**ADDENDUM REPORT TO
GEOTECHNICAL
INVESTIGATION REPORT
04632206-009**

**REPORT 04632206-009
GEOTECHNICAL INVESTIGATION
DETAILED FEASIBILITY STUDY
McARTHUR RIVER MINE EXPANSION PROJECT
McARTHUR RIVER, NORTHERN TERRITORY**

Connell Hatch are reviewing those designs for the project owner, Xstrata Zinc, in response to regulatory issues with which Golder have had no involvement. This addendum describes analysis and assessment work requested by Connell Hatch to address specific geotechnical matters raised as part of the review. The work requested was as follows.

C. DWT XSTRATA ZINC		PROJECT MacArthur River Expansion Project			
		DRAWN VAL	DATE 22/05/06	TITLE Section 1a – Downstream Stability End of Construction		REV. No 1	A4
CHECKED GSF	DATE 5/06	SCALE Not to scale		PRODUCT No 06632038	FIGURE No 1	1	A4

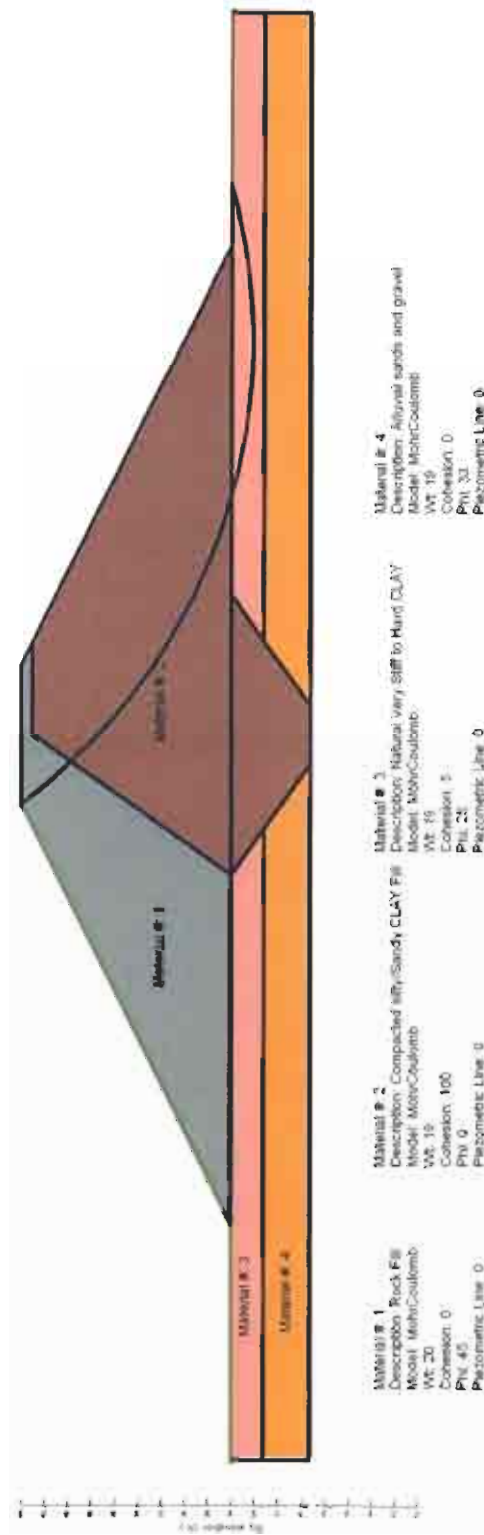
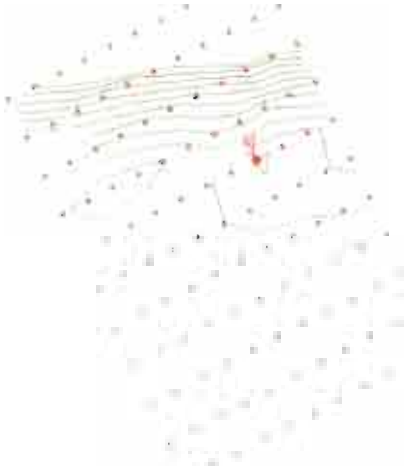
Properly engineered fill embankments of the order of 20 m high on firm foundations do not suffer end of construction failures. Figures 1 & 2 show limit equilibrium analyses for Section 1a for the end of construction condition, with the expected high factors of safety, well in excess of the criteria (Section 2.1).

CLIENT		PROJECT	
		XSTRATA ZINC		MacArthur River Expansion Project	
DRAWN	VAL	DATE	TITLE		
CHECKED	GSF	DATE	Section 1a : $k_h = 10^{-7}$ m/s		
SCALE	Not to scale		PROJECT NO.	FIGURE NO.	NO. OF SHEETS
			06632038	3	1
					A4

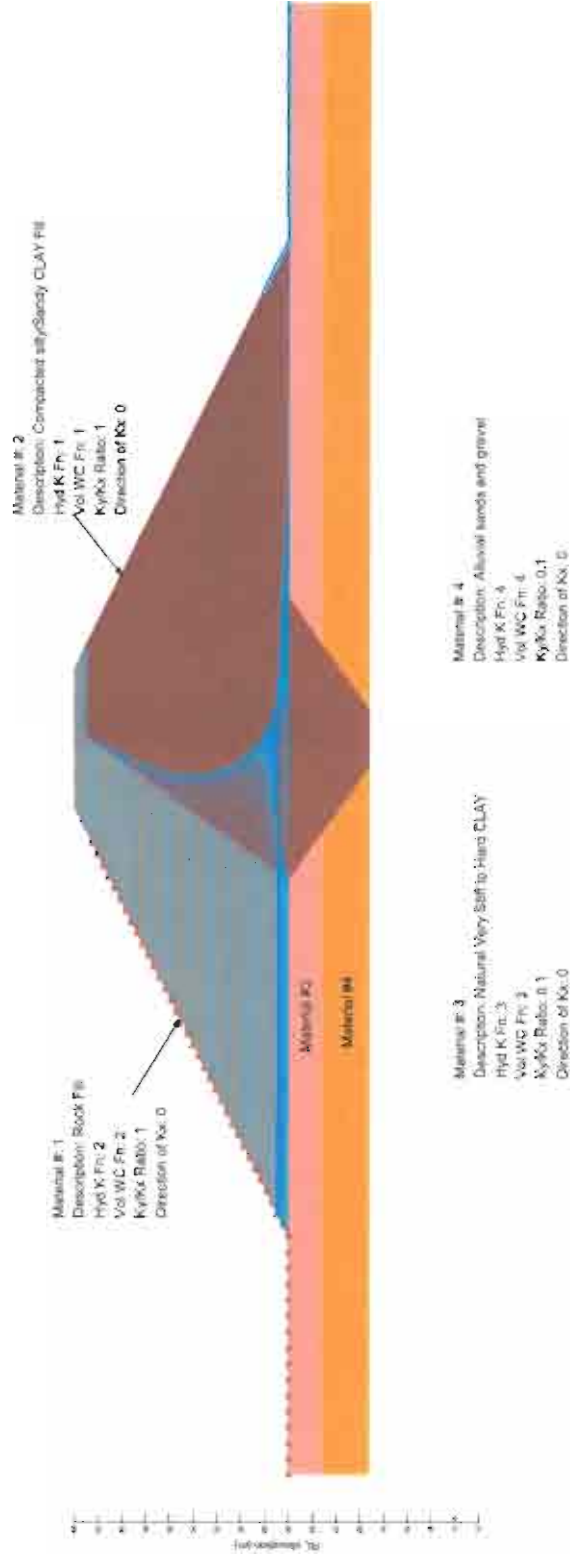
To obtain pore pressures for the "maximum flood" condition, we instead analysed the transient seepage response of Section 1a to a triangular flood hydrograph peaking at the 500 year ARI flood level, with an arbitrary 1 week rise time and 2 week fall time. The results are shown on Figures 3 & 4 for clay fill zone permeabilities of 10^{-7} and 10^{-8} m/s respectively.

The phreatic surfaces reached are relatively low, well below what would be expected from steady seepage analysis. These transient analyses assume that Zone 1A is uncracked and free of construction defects. Cracks or defects could result in a higher pore pressures further downstream within the section.

C. ENT		PRODUCT					
		XSTRATA ZINC		MacArthur River Expansion Project					
DRAWN	VAL	DATE	22/05/06	Section 1a : Downstream Stability Transient Seepage – $k_h = 10^{-8}$ m/s					
CHECKED	GSF	DATE	5/06						
SCALE	Not to scale		PRODUCT No	06632038	FIGURE No	6	REV No	1	A4

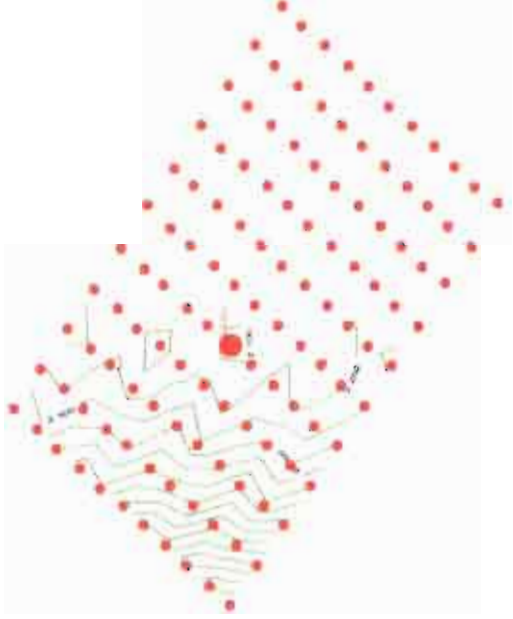
Figures 5 & 6 show downstream limit equilibrium analyses for the temporary Section 1a condition and transient seepage from the 500 year ARI flood level (Section 2.3). The probability of such a large flood occurring during the temporary exposure window is of the order of 0.2%.

The calculated factors of safety for this case (both ~ 1.4) reflect the drained strength adopted for the Zone 1A fill without seepage induced pore pressures, because the transient seepage analysis did not propagate seepage that far within the flood rise and fall time. The resulting factors of safety meet the modern "maximum flood" criteria (Section 2.1), even for this temporary condition.

Levee design should give consideration to the possibility that higher pore pressures may develop than those analysed if there are cracks or construction defects in the sealing zone, or possibly via untreated permeable foundation zones.
